**Town of Kittery
 Planning Board Meeting
 May 10, 2018**

459 U.S. Route One – Mixed-use development – Site and Subdivision Preliminary Plan Review

**RE: Town of Kittery, Planning Board Services
Preliminary Plan Review -The Homestead 459 U.S. Route 1 (Tax Map 60, Lot 24)
CMA #591.115**

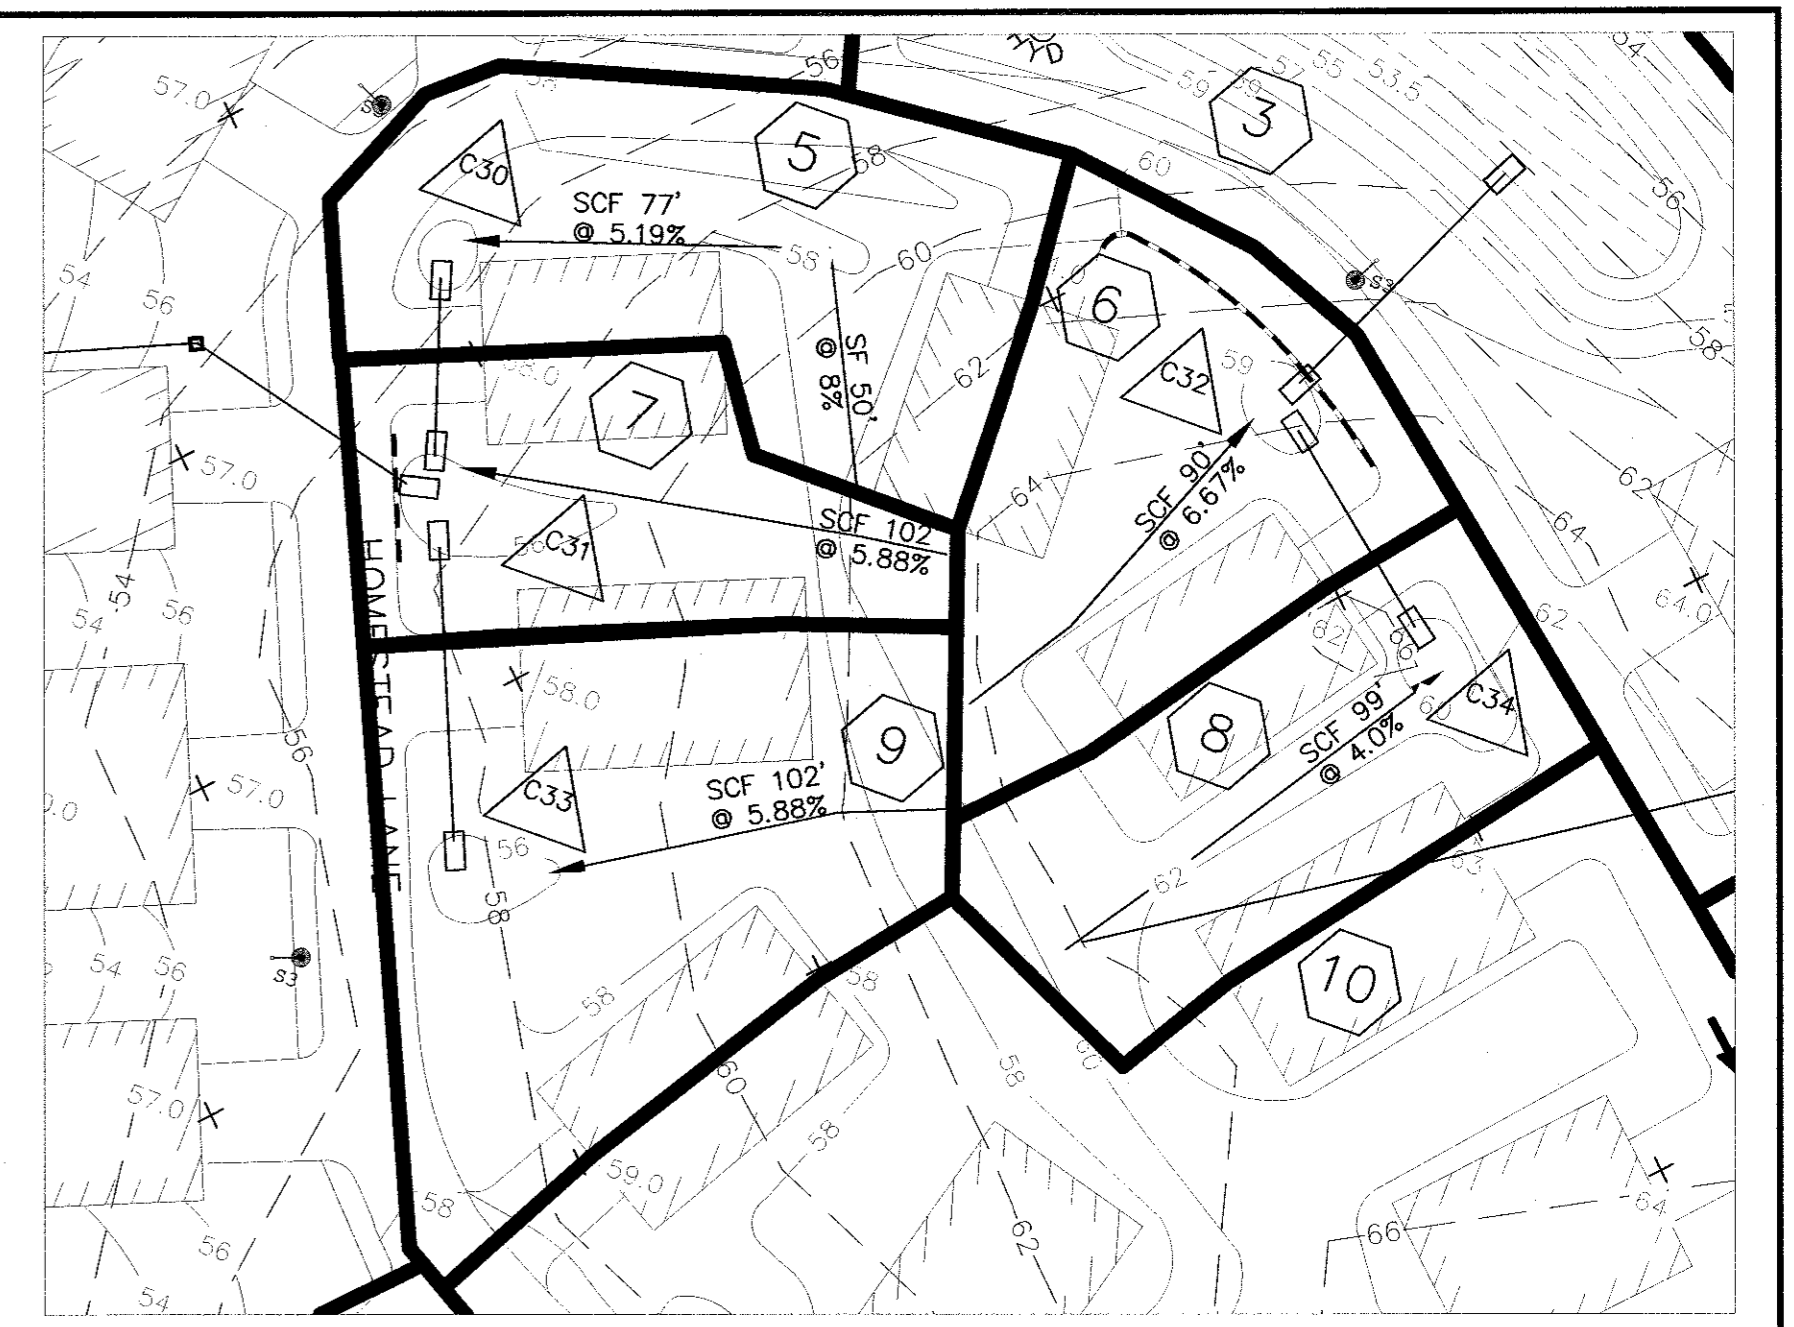
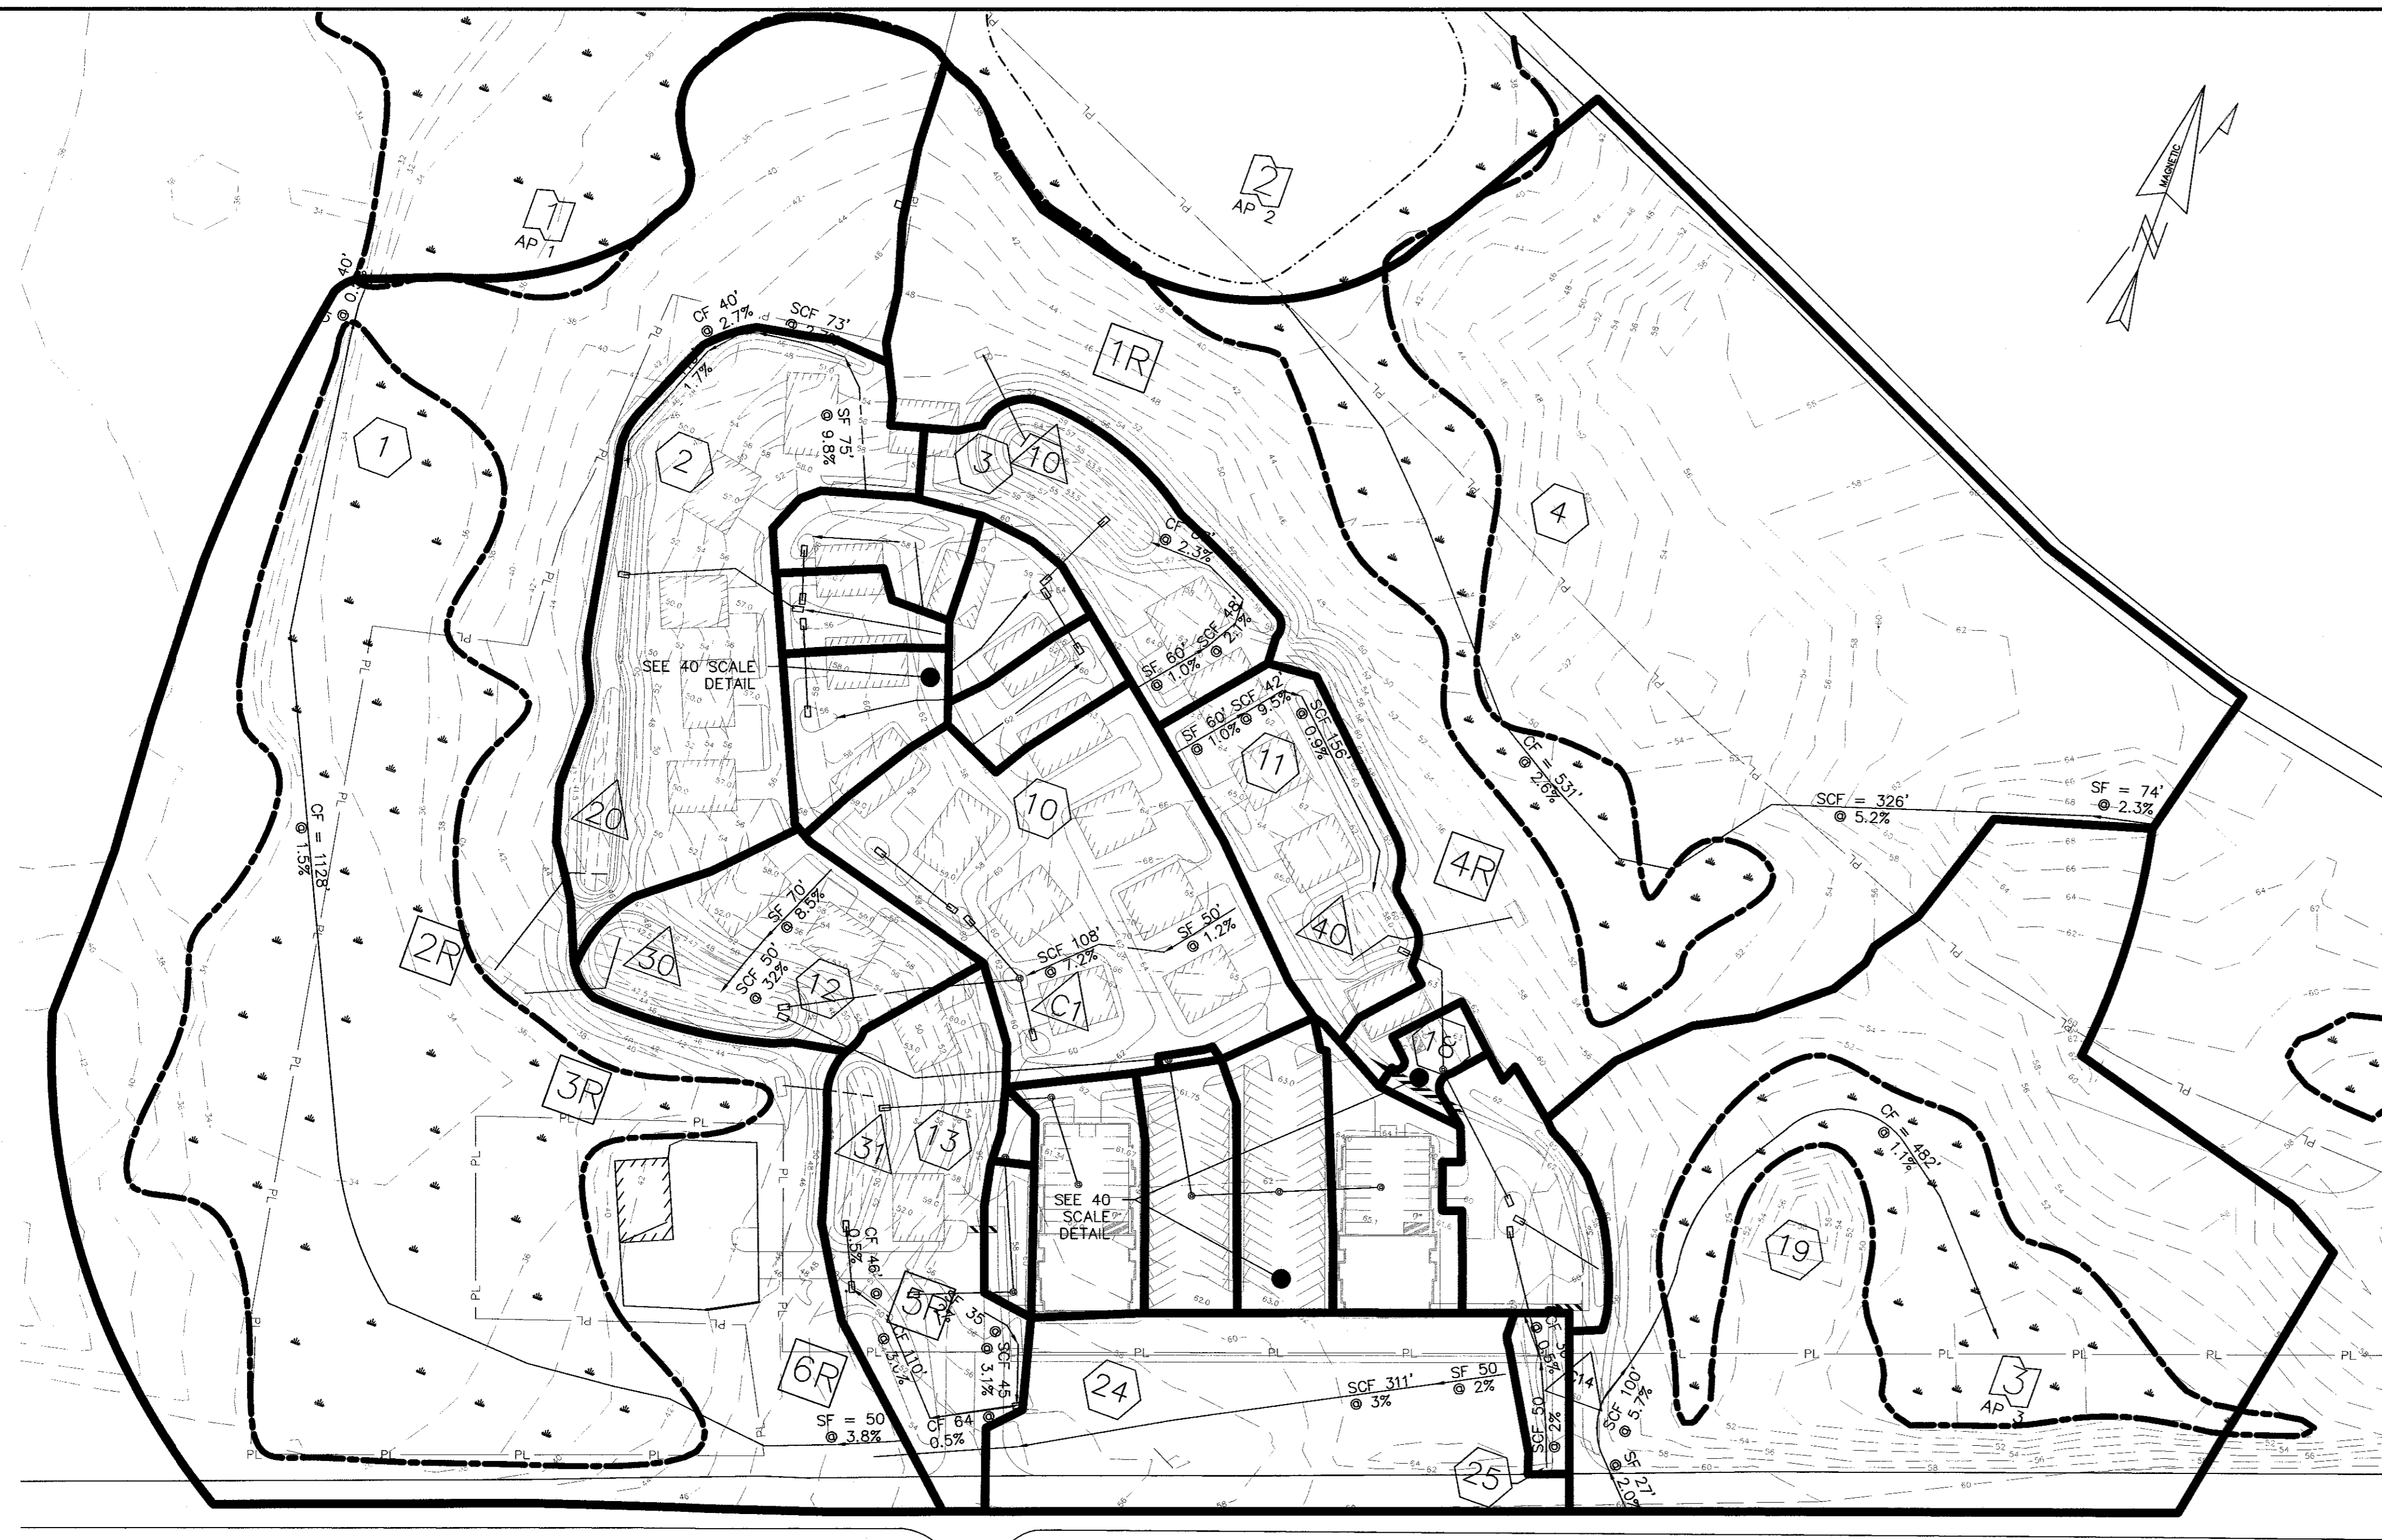
A landscaping plan was submitted – the required 30 foot planter strip along Route 1 includes 476 plants: 66 sugar maple, larch and red oak trees and 410 shrubs, the species of which are not named. Note 10 on Plan Sheet 1.1 gives spacing details which meet requirements. There are also red oaks and a few green ash trees scattered throughout the development, including along parking area edges and red cedars along the wetland edges. The planter strip will also serve to screen the parking lot. The large parking area has 6 London plane trees in a landscaped strip that divides the parking lot and three more trees along the western side. The other parking lots have trees

scattered along the edges. Section 16.8.9.4.G requires 1 tree per eight parking spaces – all parking areas meet the requirements. Notes 10-12 on Sheet 6.2 address the requirements.

- 16.8.9.4.D.I.1 The applicant should show width of the aisle adjacent to the accessible parking spaces on the plans.
16.8.9.4.G. Note 11 on Sheet 6.2 should be changed to indicate number of trees required in parking.

- 5) Landscaping – A revised Landscaping Plan is attached addressing plant materials discussed at the April 12 meeting.
- 6) MDOT Permit – The project currently has a MDOT Entrance Permit for the former Sowerby Mixed-Use Development. Both proposed entrances are in the same location that the Sowerby project had proposed. Traffic counts expected from the Homestead are substantially less than the Sowerby development, as evidenced by the submitted Traffic Report. We will contact MDOT for their review of this project in relation to the Entrance permit.
